4.2 S75W ADJUSTMENTS SCHEME ADJUSTMENT MASSING

4.3 S75W ADJUSTMENTS PROPOSED CONCEPT PLAN SCHEME

4.5 S75W ADJUSTMENTS SCHEME COMPARISON PLAZA

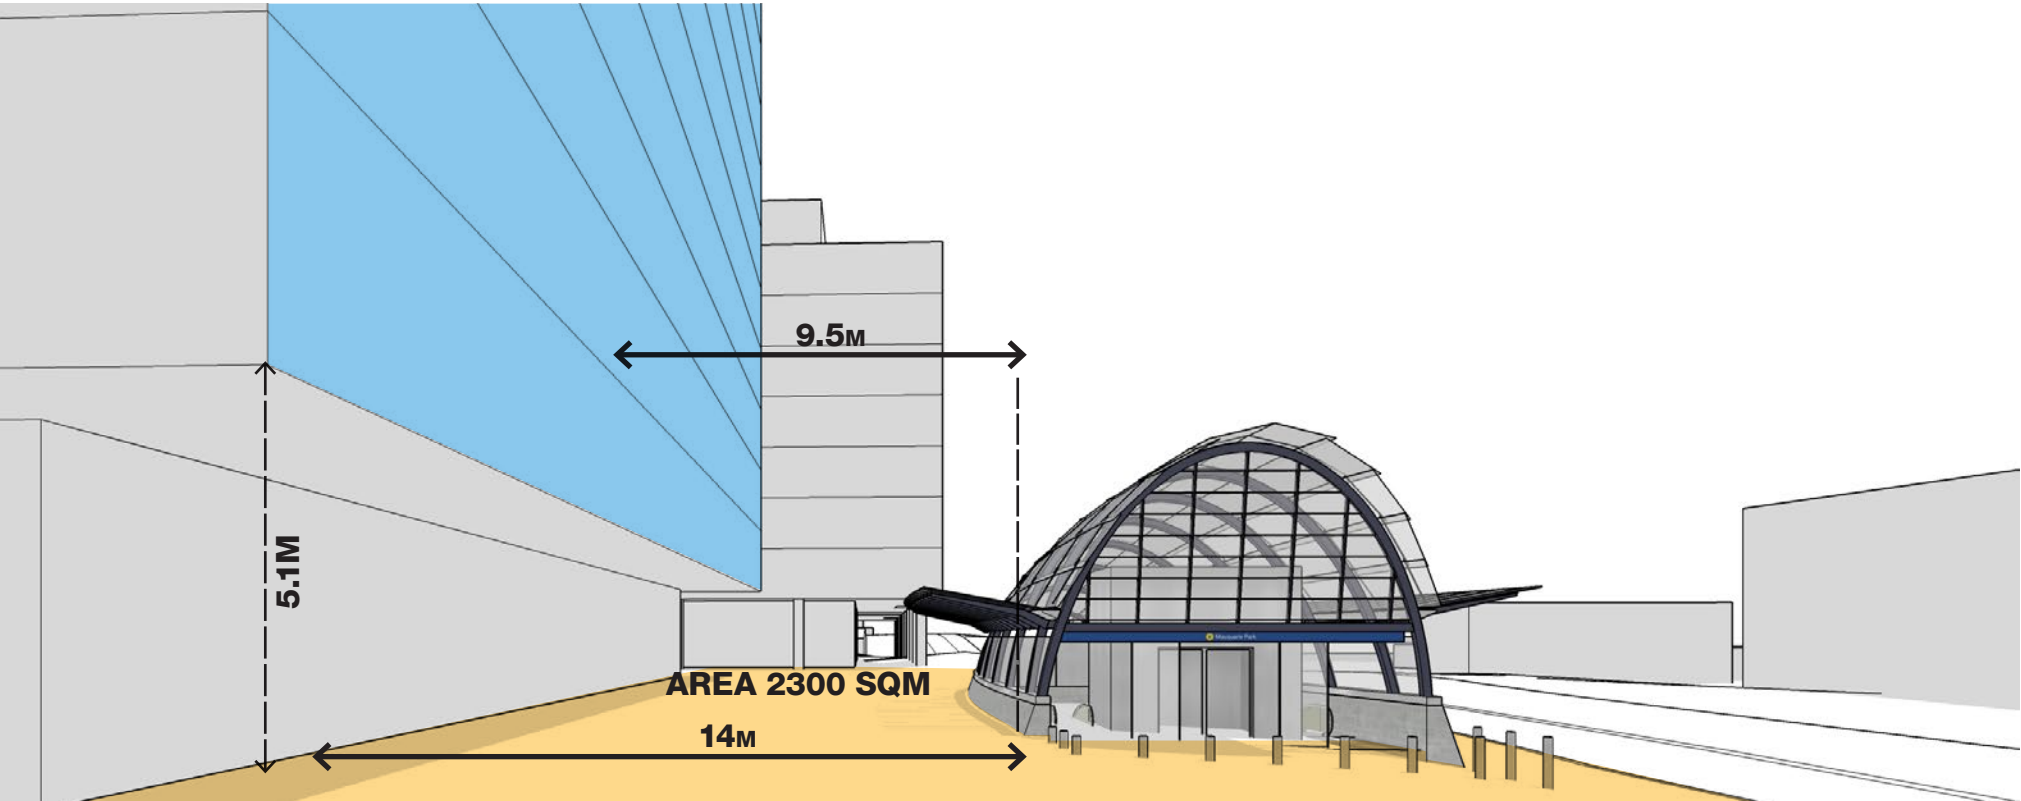
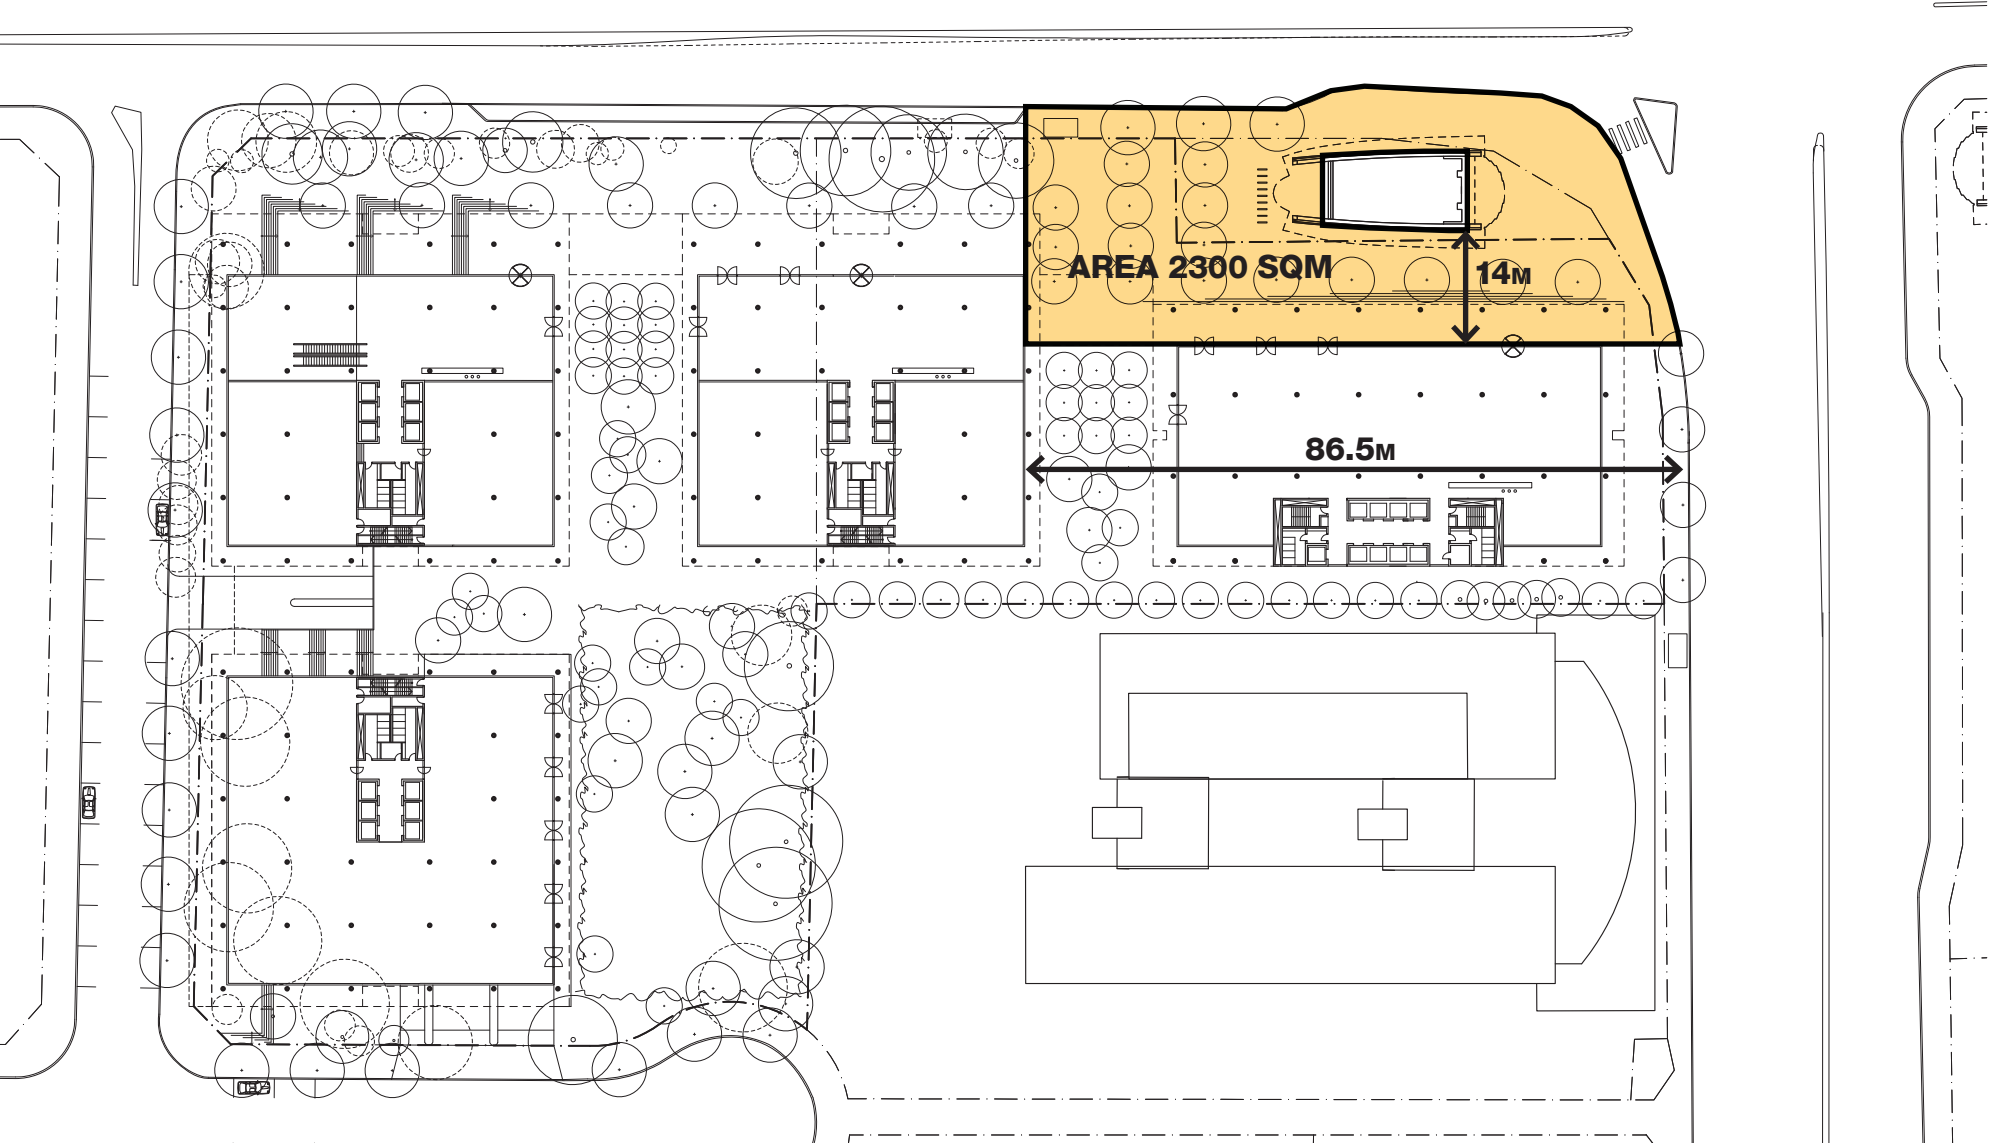
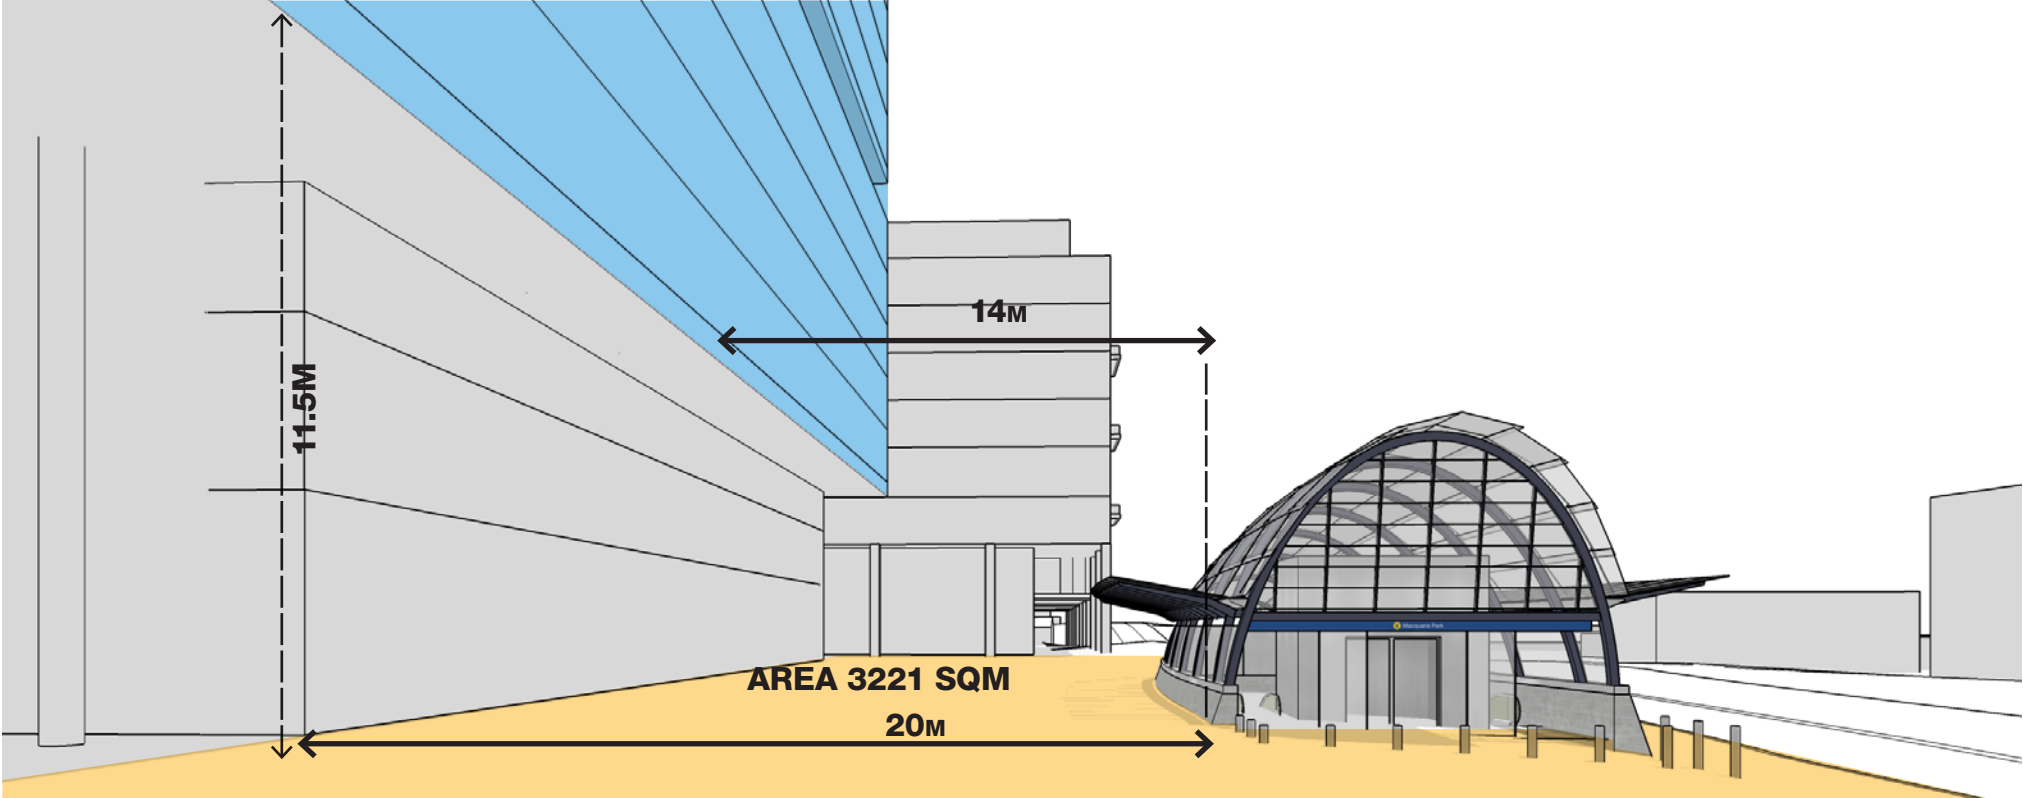
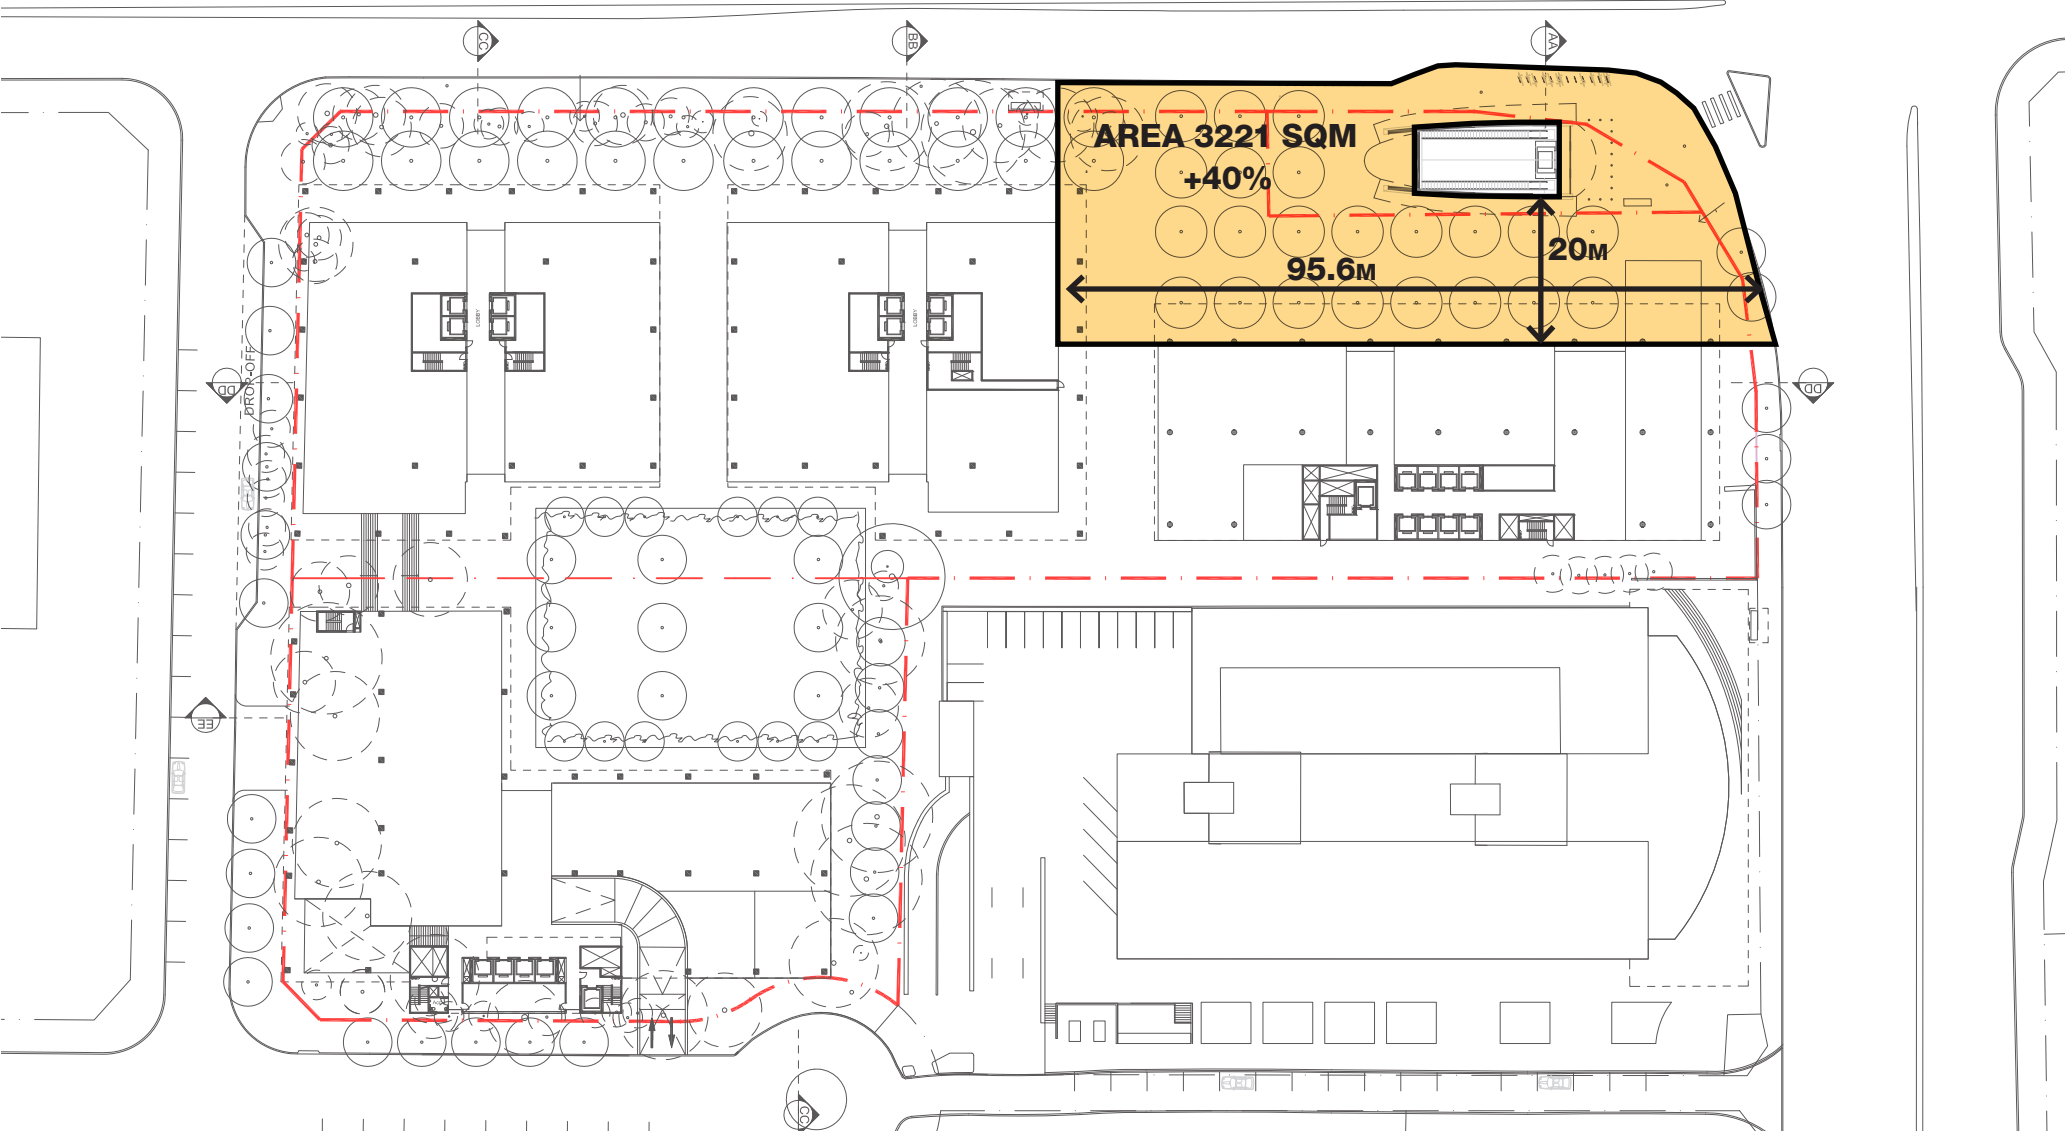
The following diagrams describe the amendments and improvements to the Station Plaza in the Section 75W submission.
The plaza has increased by 40% to be 3,221sqm (an increase of 920sqm)
